BABERGH DISTRICT COUNCIL AND MID SUFFOLK DISTRICT COUNCIL

From: Strategic Director (Place)	Report Number: M50
To: Executive Committee Strategy Committee	Date of meeting: 9 July 2012 12 July 2012

**BRAMFORD TO TWINSTEAD ELECTRICITY TRANSMISSION LINE PROJECT:
CONNECTION OPTIONS REPORT - RESPONSE TO CONSULTATION**

Project:	Bramford to Twinstead Tee Connections	
Title:	Interim Alignment	
Drawing No:	Figure 12	
Date:	May 2012	TEP Ref No: G1980.599b
Drawn:	Checked:	Approved:
CB	CH	IJG

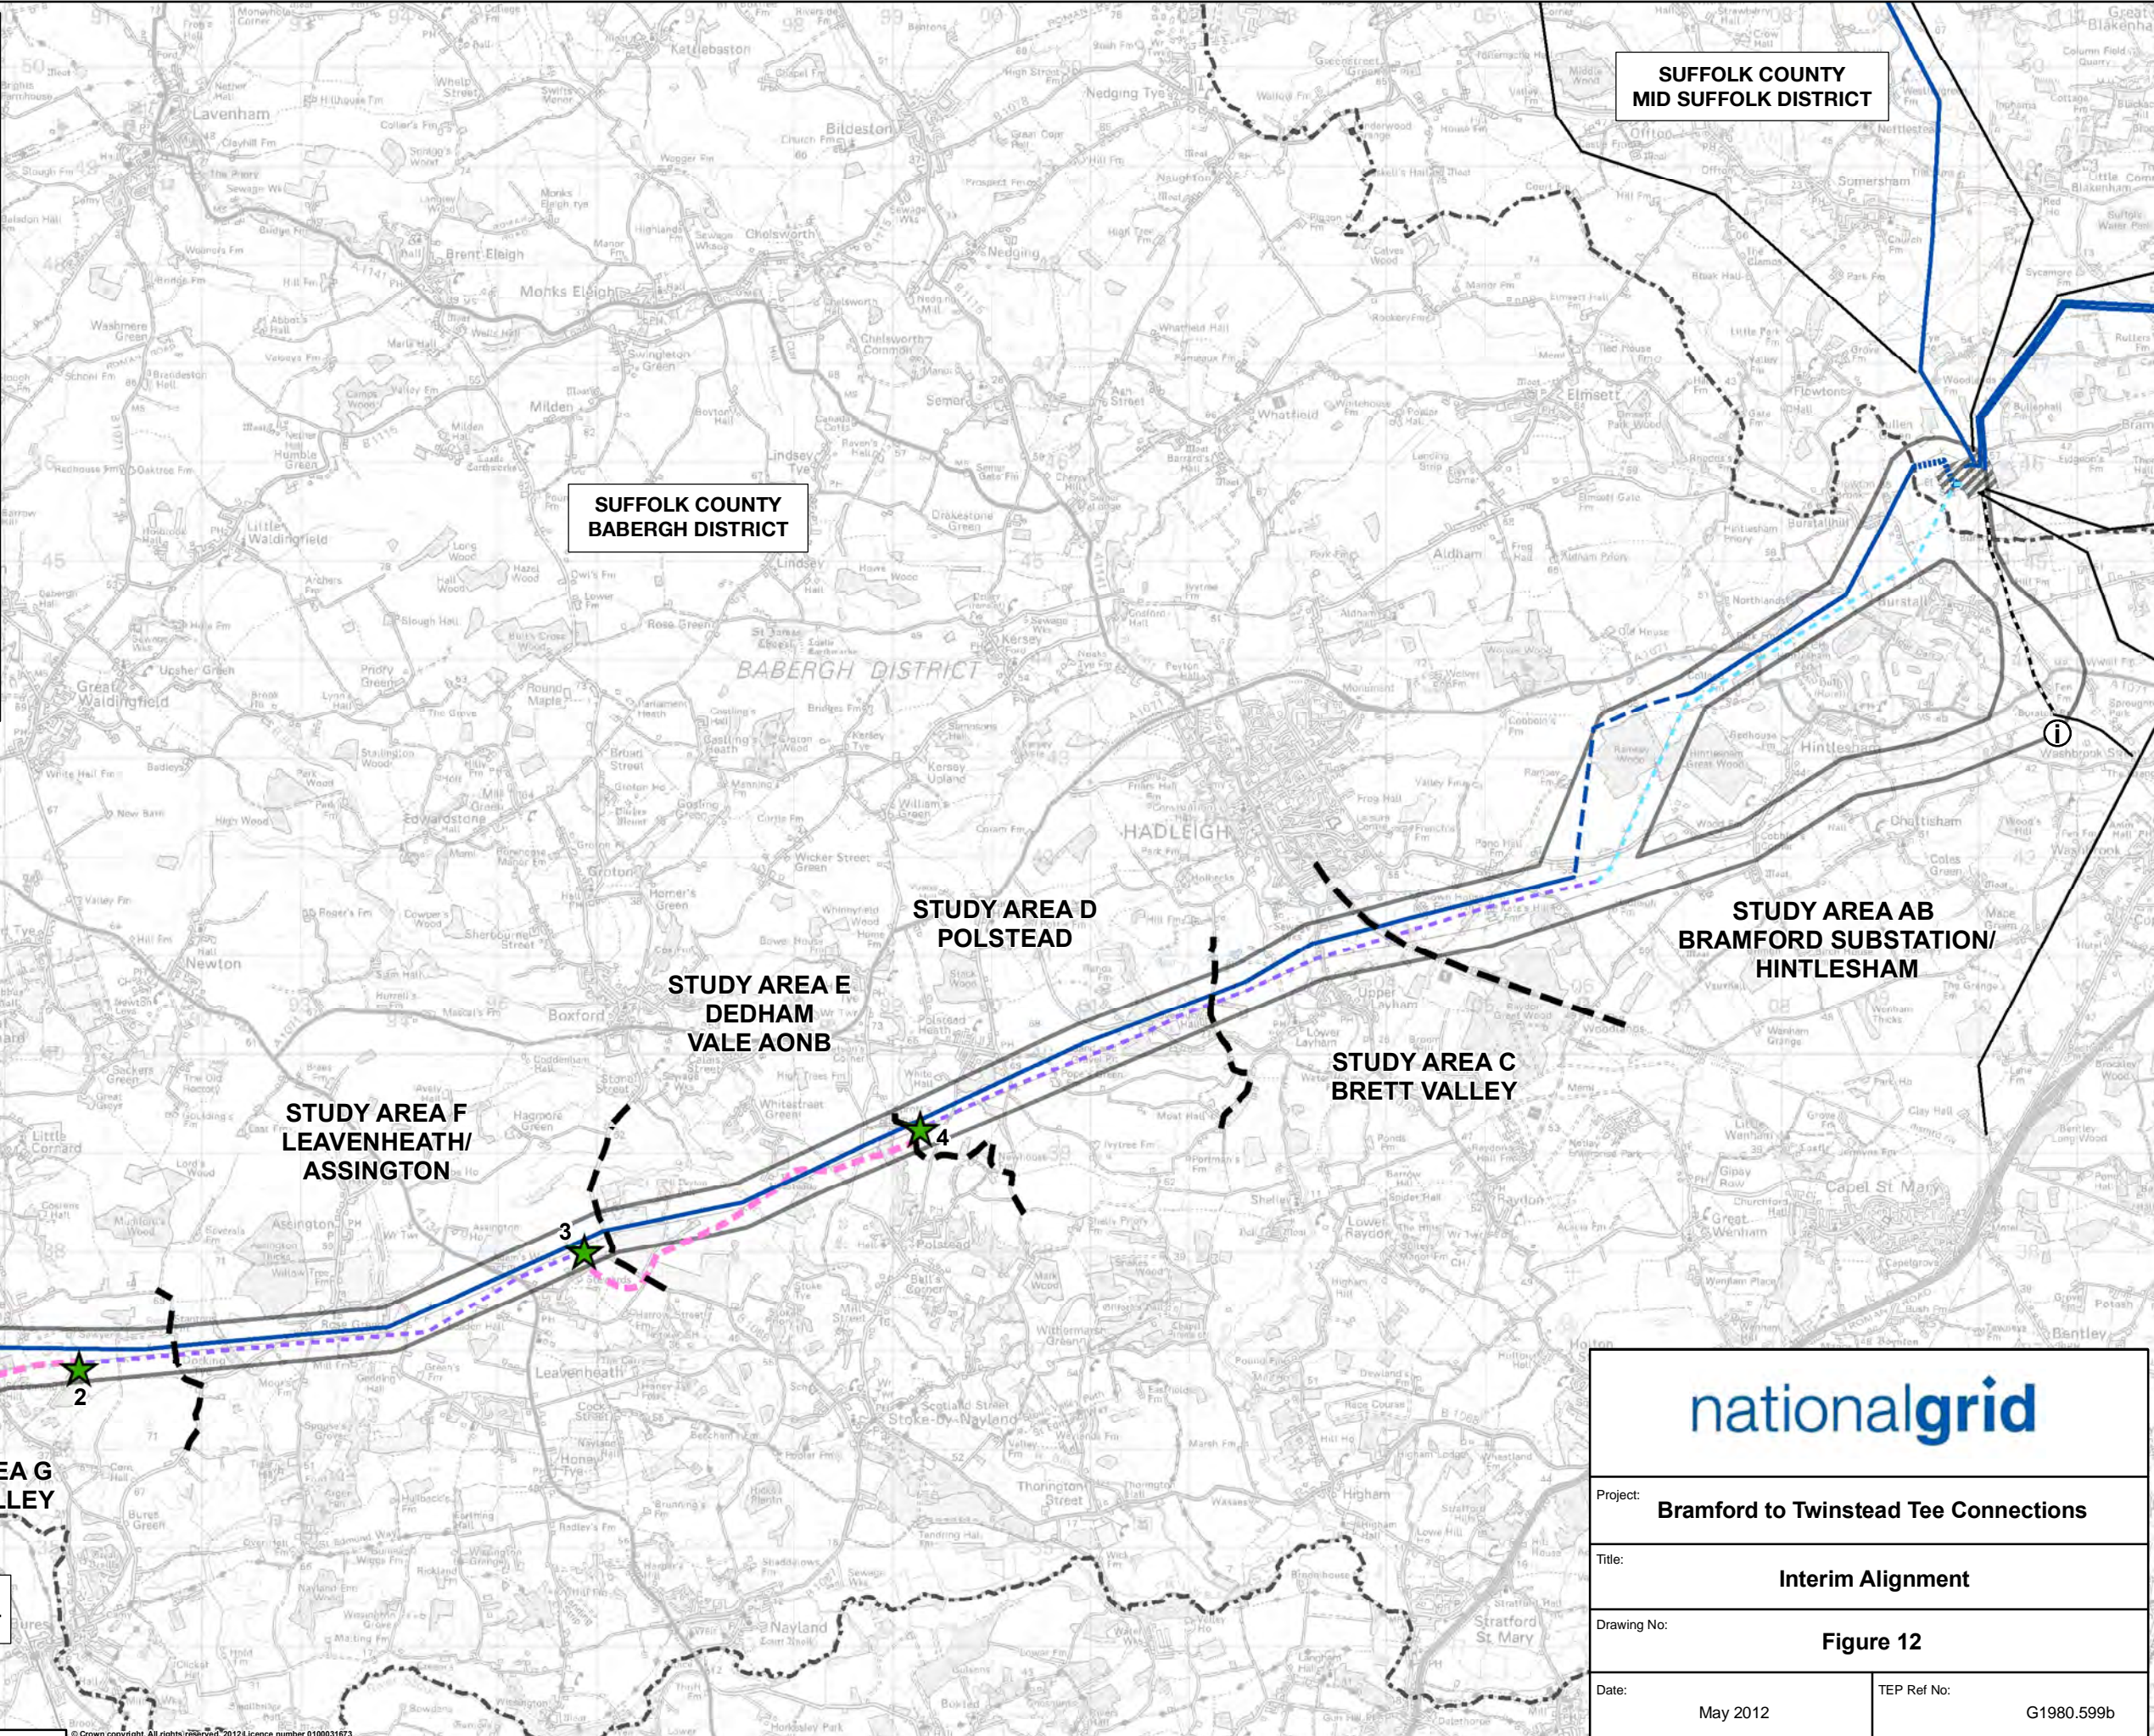
- 9.5 The COR was published on 29 May and sets out the approach National Grid has taken towards the selection of an interim alignment which would be a generally parallel alignment to the south of the existing 400kV overhead line. The connection would involve the construction of 21km of new overhead line and 8km of underground cable in two short sections in the Dedham Vale AONB and the Stour Valley. The overhead line would be constructed using lattice type pylons similar, but not identical in appearance, to the existing pylons. Large scale plans showing the interim alignment will be on display at the respective meetings however a small scale plan is attached for reference in Appendix Two.

- 9.31 It is however evident that the creation of additional overhead lines to the west of the Bramford substation and the formation of a new overhead line approximately 400 metres to the south east of the existing line would create a wire ‘box’ around Canes Farm, a Grade 2 listed building and the nearby residential properties. It would also cumulatively add to the already heavily despoiled landscape around the Bramford substation which is particularly noticeable from Tye Lane, Bramford to the north.

- 9.33 In order to avoid Ramsey Wood, a Site of Special Scientific Interest, the proposals would result in the creation of a further wire 'box' to the south of the A1071 and Hadleigh Bee Farm. This in combination with the use of a different pylon design to that already used would not achieve synchronicity with the existing overhead line. As such the proposals would be visually intrusive and highly detrimental to the character of the surrounding countryside, especially when viewed from the A1071 road. As a consequence there is a very compelling case for the route to be placed beneath ground within this study area.

- 9.38 The presence of the existing overhead lines, along with the other reasons advanced by National Grid, does not provide sufficient justification to support the construction of a further 400kV line through the valley which will be of a different design and appearance to those already in existence. Representations should therefore continue to be made to ensure that this section of the route is placed beneath ground in accord with the views expressed by Community Forum Members and local residents.

- 9.42 While it acknowledged that the character of Study Area D is not as sensitive to change to that within the adjoining Areas C and E, it does nonetheless form an intrinsic part of the South Suffolk landscape. In view of the need for the line to be placed beneath ground in Study Area C and National Grid's proposals to underground the line in Study Area E it would be perverse for such a short section (3.3km) to remain above ground. Such a solution would obviate the need for a sealing end compound to be constructed, the implications of which are discussed in the next section.

- 9.46 It is evident that insufficient consideration has been given to the potential consequences of locating the sealing end compounds on the margins of the AONB and adverse visual impacts associated with their construction. The scale and nature of the sealing end compounds is such that there is further justification to suggest that the entire route is placed beneath ground.
- 9.47 In addition to the above it is known that National Grid will be reviewing the location of existing overhead lines in designated landscapes with the view to establishing whether it is possible to secure environmental improvements. There is therefore a case here for the company to be urged to remove the existing 400kV line in the Dedham Vale AONB and place it beneath ground.

- 9.51 While it is acknowledged that the character of the study area is not as sensitive to change when compared with Study Area E, it does nonetheless form an intrinsic part of the South Suffolk landscape. The construction of a new overhead line involving the use of a different pylon design which does not achieve synchronisation with the existing overhead line would be visually intrusive. The harm to the character of the countryside would be especially noticeable when looking east from Stanton's Farm into the Special Landscape Area and from the A1071 road between Newton and Boxford. At this stage the precise location of the sealing end compound is not known and depending upon the eventual siting it could be visible from the A1071 road. There is therefore a compelling case for the route to be placed beneath ground in this study area.

- 9.54 The COR acknowledges that the landscape within Study Area G is of more than local value. As a result an underground option is proposed to avoid the major negative effects associated with the construction of an overhead line. While this is to be welcomed, the construction of sealing end compounds to service the underground cables is not. In addition it still remains unclear as to whether a substation will be required within the vicinity of the Twinstead Tee. As such Members are invited to support their Essex and Braintree colleagues and local interest groups in pressing National Grid for an early resolution on this point.
